# REGIONAL REVIEW NOTIFICATION

**ARC REVIEW CODE:** R1709252

**Name of Proposal:** 740 West Peachtree (DRI 2707)

## Development of Regional Impact Assessment of Consistency with the Regional Transportation Plan

DRI NUMBER:	2707
OVERALL SITE AREA:	1.73 ACRES
CURRENT ZONING:	SPH-16-SA1
CURRENT ADDRESS:	740 WEST PEACHTREE ATLANTA, GA 30308
OWNER:	PORTMAN HOLDINGS
<b><u>PARKING:</u></b>	
PROPOSED:	1039 SPACES

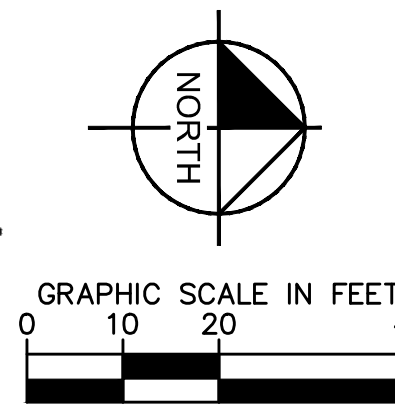
The project is bounded by public roadways on all sides with existing development surrounding the site. The site plan does not depict adjacent parcels or their driveways to determine if inter-parcel connectivity is planned or possible, nor is it mentioned in the traffic analysis.

The site plan does depict some internal sidewalks however bicycle facilities are not depicted.

The site is bounded by public roadway on all sides with public sidewalk connectivity already existing. Adjacent parcels are developed. The site plan does not indicate bicycle access or connectivity to adjacent parcels being added.
